##### **1958 Agreement – Consideration of draft amendments to existing Regulations submitted by GRE**

### **Proposal for Supplement 44 to the 03 series of amendments to Regulation No. 37 (Filament lamps)**

#### **Submitted by the Working Party on Lighting and Light-Signalling\***

Figure 1  
Main drawing

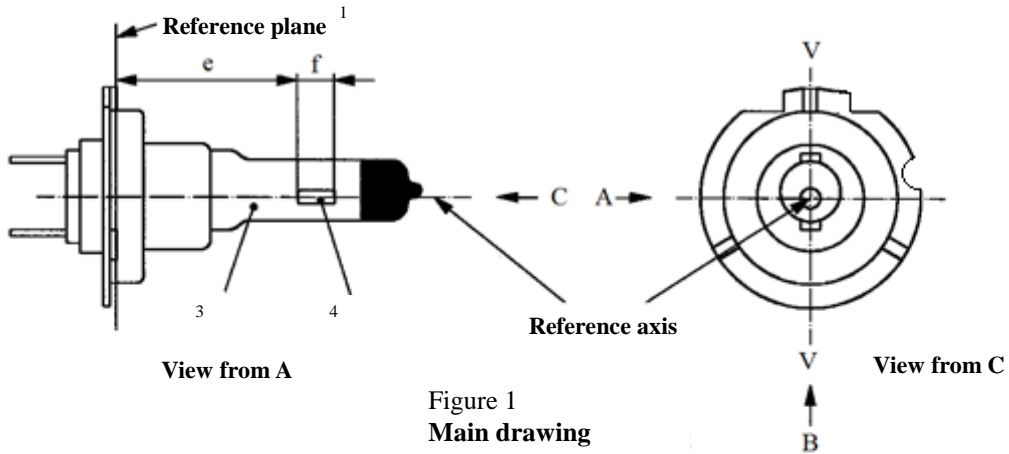
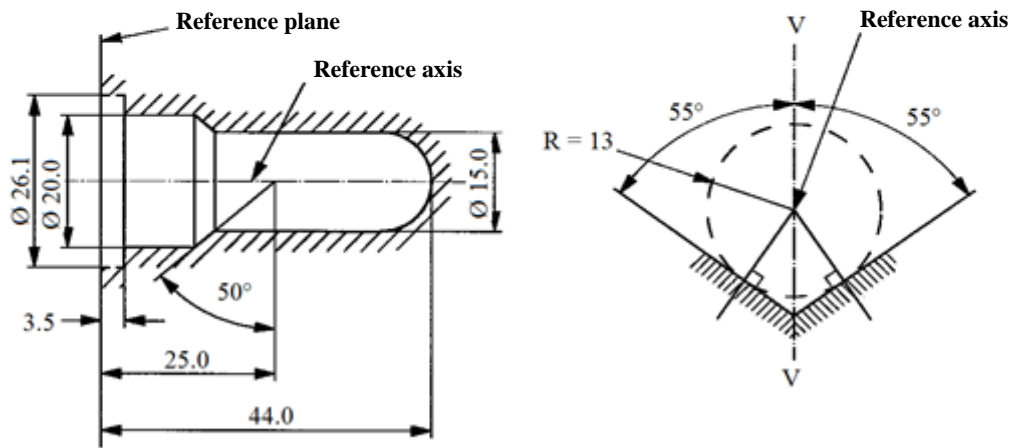
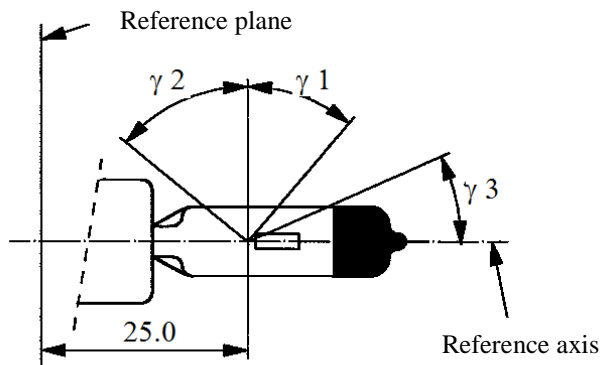
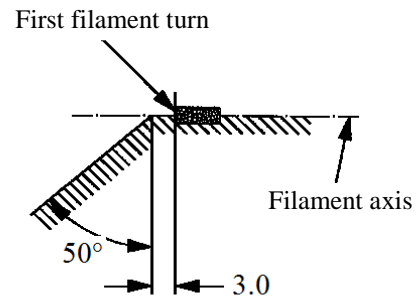
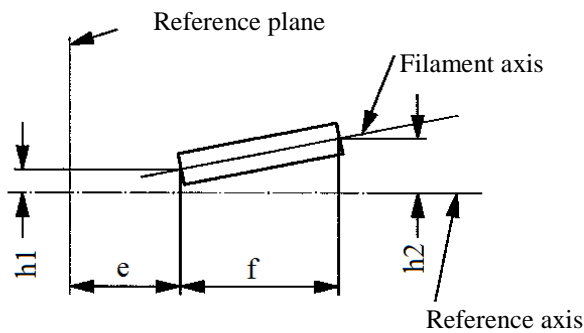
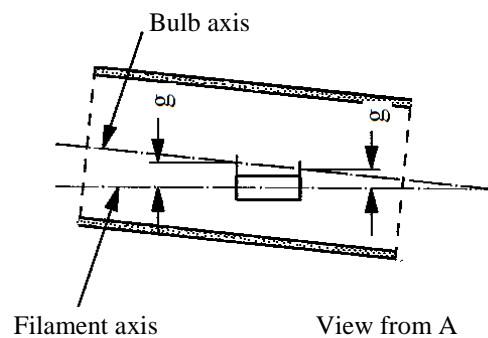
*After sheet H17/6, add new sheets H18/1 to 6, H19/1 to 4 and H20/1 to 4, to read (see following pages; one page per sheet):*

Sheet PR21/5W/1, the following drawing,

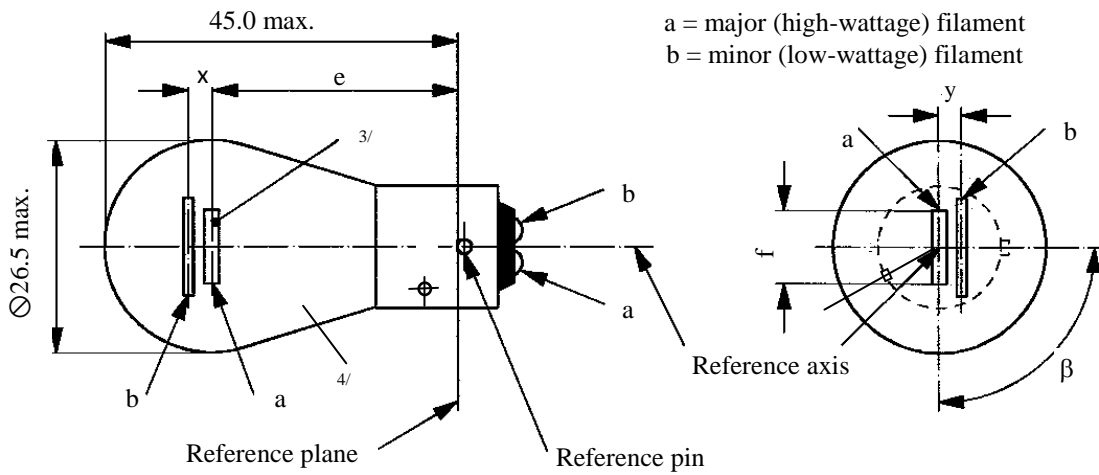
amend to read:

"2.4. Restricted colour boundaries.

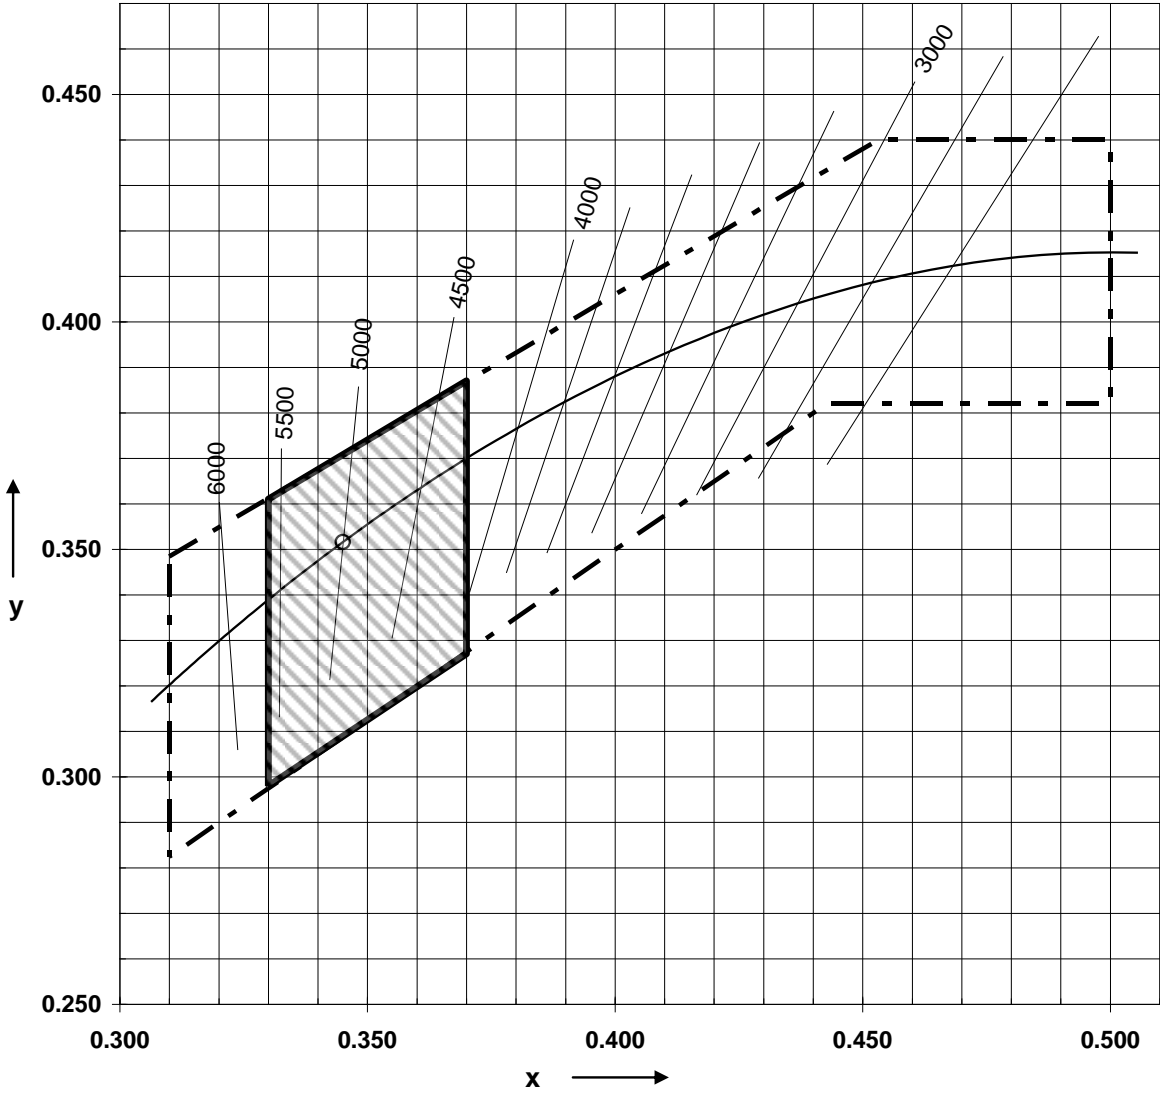
*Annex 5, insert a new paragraph 2.4., to read:*

The following figure shows the colour tolerance area for the colour white (within the dashed lines) and the restricted tolerance area for the filament light source H20 (shaded area within the solid lines) in the CIE chromaticity coordinate system (x, y).
